COLLETON PLACE SUBDIVISION

APPLICATION NUMBER 17 DATE January 4, 2007
APPLICANT Colleton Place Subdivision
REQUEST Subdivision

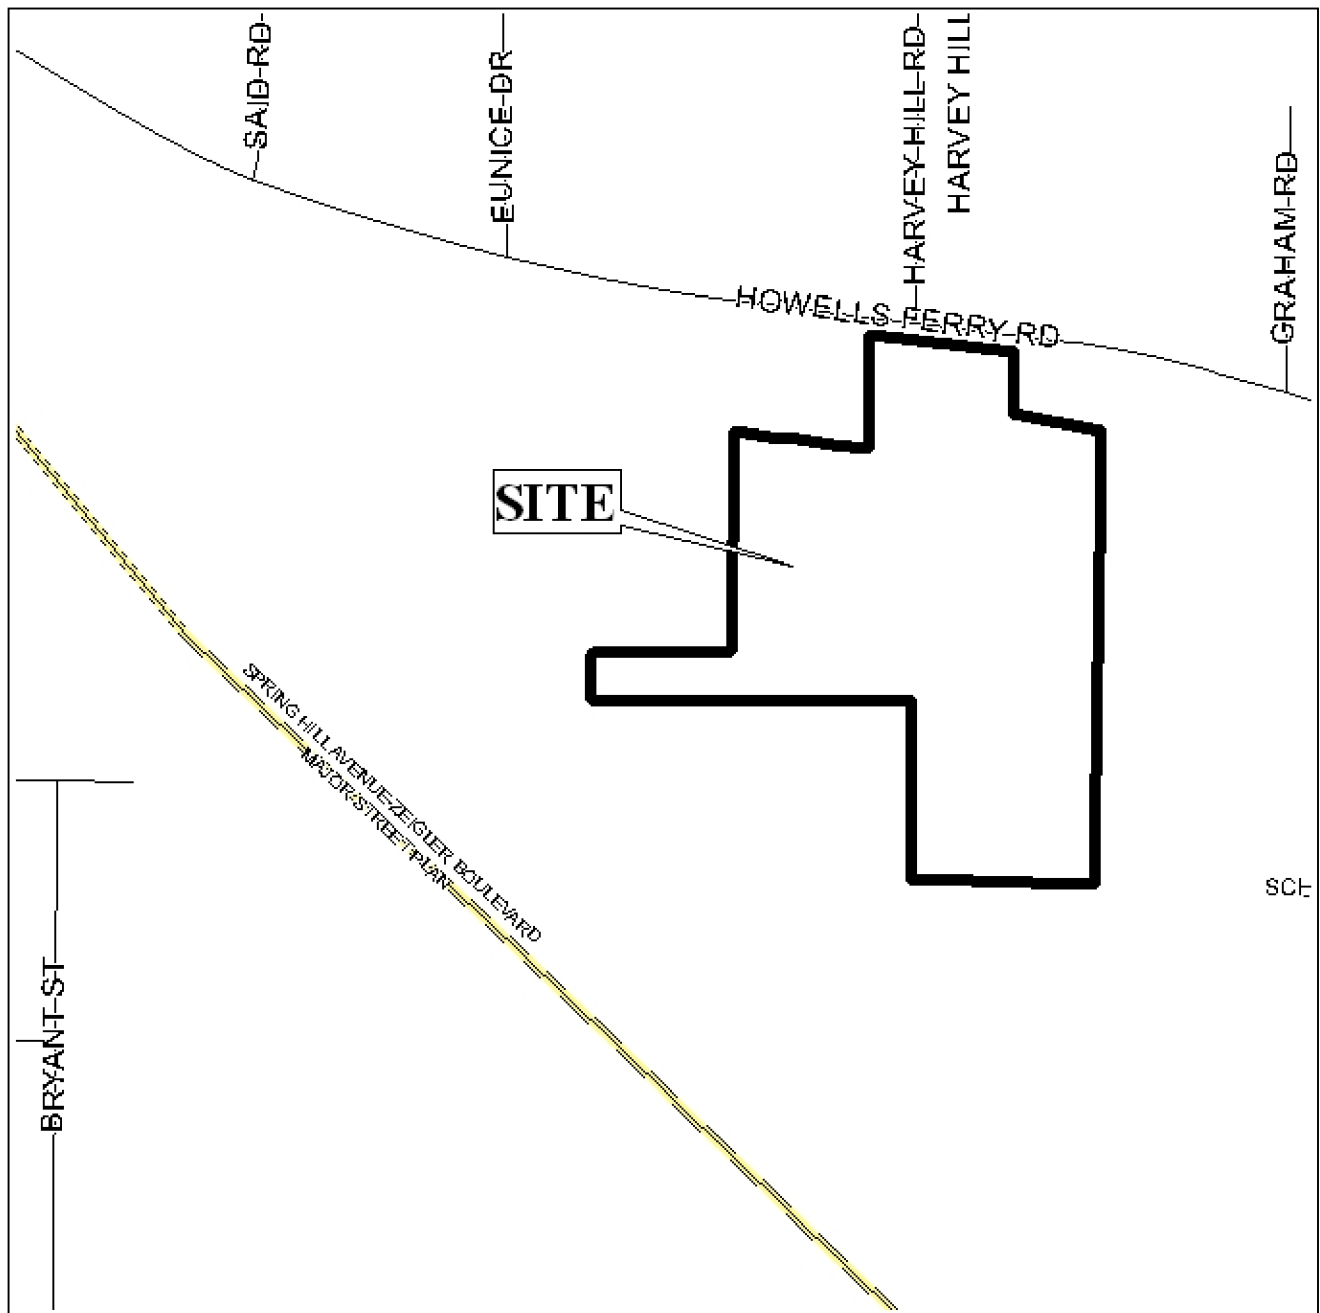
It appears that many of the corner lots do not comply with Section V.D.5. of the Subdivision Regulations; specifically, their widths are not adjusted to accommodate the required minimum building setback from both streets, thus the resulting buildable area width may not be sufficient.

Common areas are proposed within the round-about, a road median, and as “park” and detention areas. A note should be placed on the final plat, if approved, stating that maintenance of the detention and common areas is the responsibility of the subdivision’s property owners.

Stormwater detention facilities are depicted on the plat. While the site is located in the county, compliance with the City of Mobile stormwater and flood control ordinances will be required. A letter from a licensed engineer certifying compliance with the City’s stormwater and flood control ordinances should be submitted to the Planning Section of Urban Development prior to the signing of the final plat, if approved.

Based on the preceding, this application is recommended for Holdover until the February 1, 2007 meeting, with revisions due by January 8, 2007, to allow the applicant to undertake the following: 1) revision of the plat to meet the minimum lot size requirements contained in Section V.D. of the Subdivision Regulations, or provision of a statement justifying the request for reduced lot sizes and setbacks; 2) placement of a note on the plat stating that the approval of all applicable federal, state and local agencies will be required prior to the issuance of any permits or land disturbance activities if wetlands occur on the site; 3) placement of a note on the plat stating that any lots which are developed commercially and adjoin residentially developed property must provide a buffer, in compliance with Section V.A.7. of the Subdivision Regulations; 4) placement of a note on the plat stating that provision of a certification letter from a licensed engineer to the Planning Section of Urban Development, certifying that the stormwater detention and drainage facilities comply with the City of Mobile stormwater and flood control ordinances, is required prior to the signing and recording of the final plat; 5) placement of a note on the plat stating that maintenance of the detention and common areas is the responsibility of the subdivision’s property owners; and 6) labeling of all lots with size in square feet, or placement of a table on the plat containing the lot size information.

DETAIL SITE PLAN

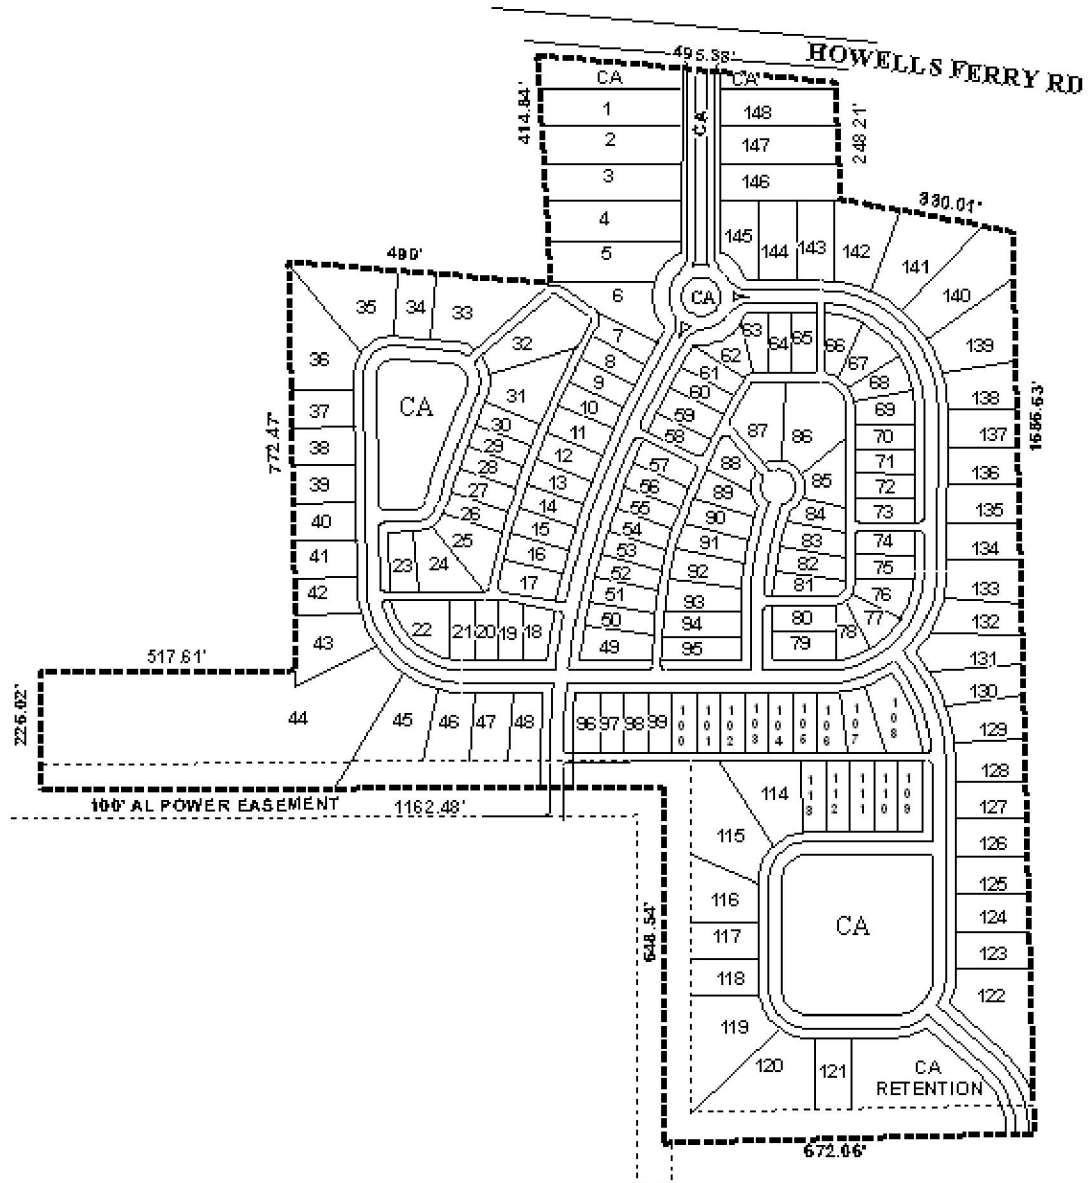
The proposed lot sizes, setbacks, alleys and common areas indicate that the applicant is attempting an “innovative” subdivision, however, no specific statement to this end has been provided by the applicant. While innovative subdivisions that embody traditional neighborhood development design elements are encouraged, the site is far removed from public transit service and is a “greenfield site” - a site that is currently minimally developed. It should also be pointed out that some of the proposed lot sizes and lot widths do not meet the minimum width or size requirements of Sections V.D.2. of the Subdivision Regulations. If it is the applicant’s intent to invoke innovative design or traditional neighborhood design consideration, the applicant should provide a statement indicating the design intent for the subdivision, if innovative under Section VIII.C. of the Subdivision Regulations, or revise the subdivision so that all lots meet minimum standards.

Access management is a concern as it relates to public safety. The subdivision, as proposed, will have only one connection to a public street. Street-stubs are proposed at two locations on the South side of the site, but there are no connections to other streets immediately accessible from the street-stubs, thus access to other public streets will not occur within the near future. At least one additional connection to an existing public street would improve accessibility for emergency vehicles.
